Product Change Notice (PCN)

Subject: Change package lead frame of UPD720114GA due to assembly machine

UPD720114GA PCN changing points of Package outline

Doc No. APTE4-BB-21-0012

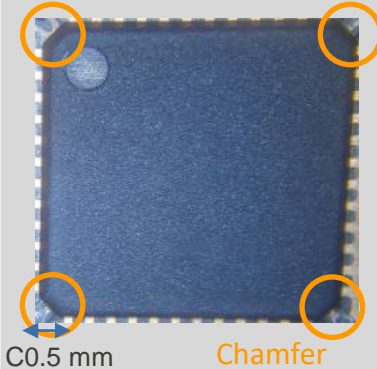
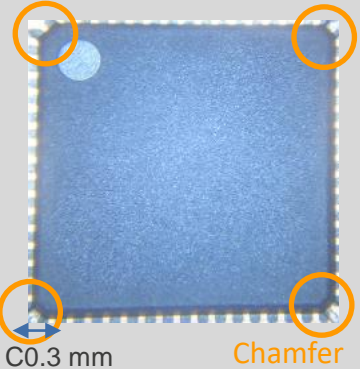
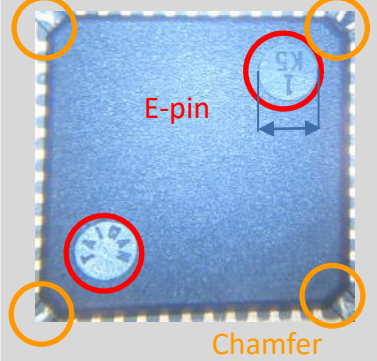
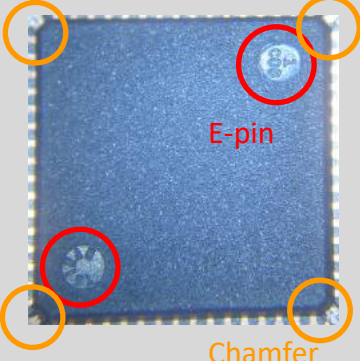
TQFP 7*7 Layout	POD Layout	3rows L/F layout(current)	5rows L/F layout(new)	Different Area
Package Top View				<ol style="list-style-type: none"> Chamfer size is different 3x12 layout : C0.5 mm 5x14 layout : C0.3 mm
Package Bottom View	Undefined			<ol style="list-style-type: none"> E-pin size is different 3x12 layout : 1.4 mm 5x14 layout : 1.0 mm Chamfer size is different 3x12 layout : C0.5 mm 5x14 layout : C0.3 mm

Chamfer and E-pin size are different. There are no other dimensional changes.
No impact for reliability about the changes
